21-25

**Re:- Report on existing water main and foul sewer at 432A Orwell Park Green**

Figure 1:- Section through existing boundary wall showing levels for existing water main and foul sewer

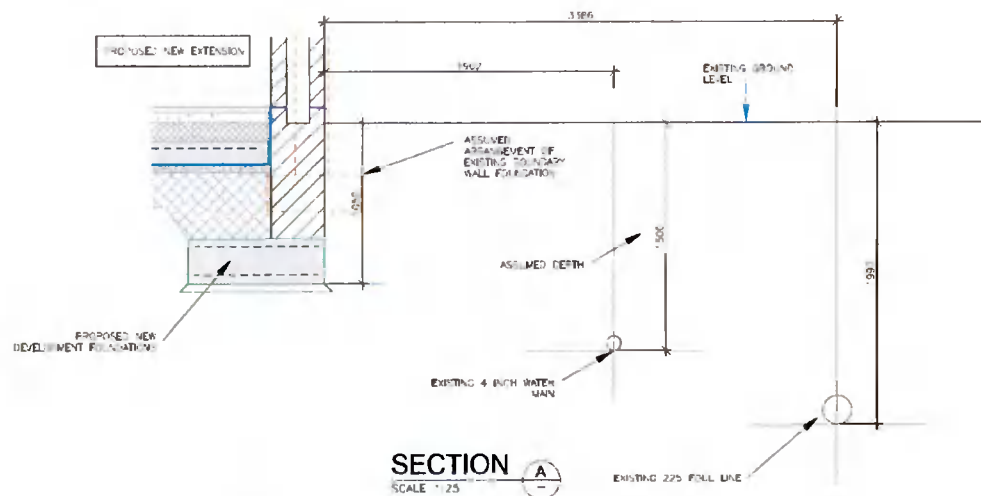
Following a review of the planning drawings for the proposed extension at the above address, I would recommend that the existing boundary wall be demolished to allow for a new foundation for the extension. The bottom of the new foundation should be 1050mm below the existing ground, so as not to induce any ground pressures on the existing water main and foul sewer as shown in Figure 1 below. The position of the existing services are shown on the architects plan below along with an extract from the drainage record maps. See Figure 2 and 3 below.
